Docket No. 50-346
Serial No. DB-88-009

SUBJECT: NON-VITAL POWER SUPPLY IN VALVE INTERLOCK LOGIC

Carolina Power & Light Company
H. B. Robinson Unit 2
Operating Plant Feedback - Non-vital Power
Supply Used in Valve Interlock Logic

TYPICAL ARRANGEMENT

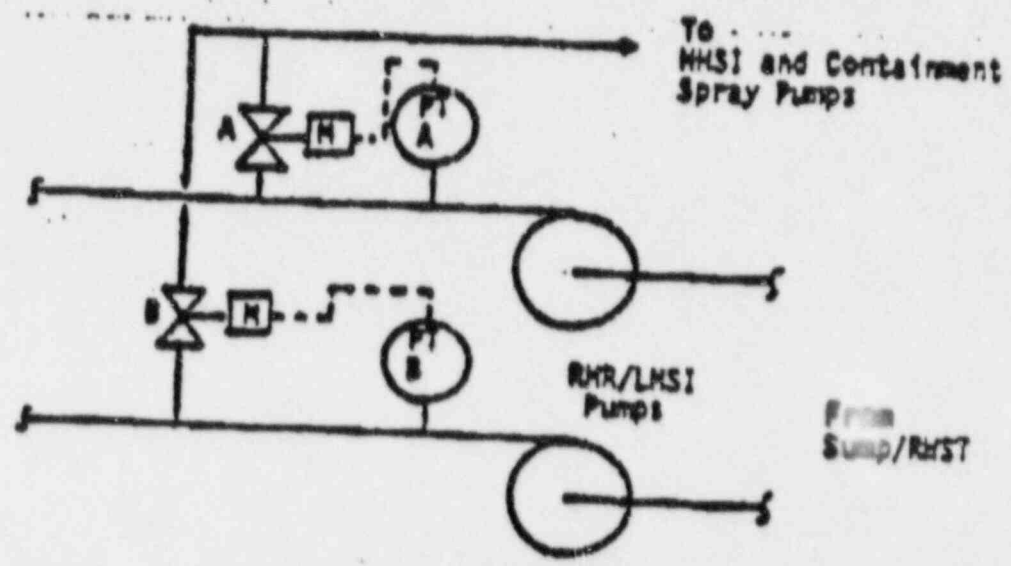
The potential problem involves the capability to establish post-LOCA recirculation flow. Please refer to the attached sketch. During certain accidents, a flow path from the containment sump through the Residual Heat Removal/Low Head Safety Injection (RHR/LHSI) pumps, to the High Head Safety Injection (HHSI) pumps is required. To establish this flow path, valves A or B must be opened. However, valves A and B are also interlocked with pressure transmitters A and B, respectively. The interlock logic includes a feature such that these valves cannot be opened when the RHRS pressure is above about 200 psig to 250 psig. The intent of this interlock logic is to insure that valves A and B remain closed during normal RHRS cooldown operation. This precludes the possibility of overpressurizing the lower pressure piping in the suction of the HHSI and Containment Spray Pumps.

For the operating plant, the pressure transmitters A and B were powered from non-vital power. The situation resulted in the potential where valves A and B could be blocked from opening if the non-vital power failed, even though the valves were powered from separate emergency power.

It is recommended that you review the current interlock logic and power arrangements for the subject valves and instrumentation to insure that failure of non-vital power still allows both valves to be opened. It is acceptable for the single failure of emergency power to preclude one valve from being opened.

If remote valve operation cannot be assured, several interim changes could be made to allow continued plant operation. These include bypassing the interlock logic or manual operation of the valves using the handwheel. (Note: The corresponding emergency procedure should reflect any changes.) Longer-term solutions include changing power supplies or modifying the interlock logic.
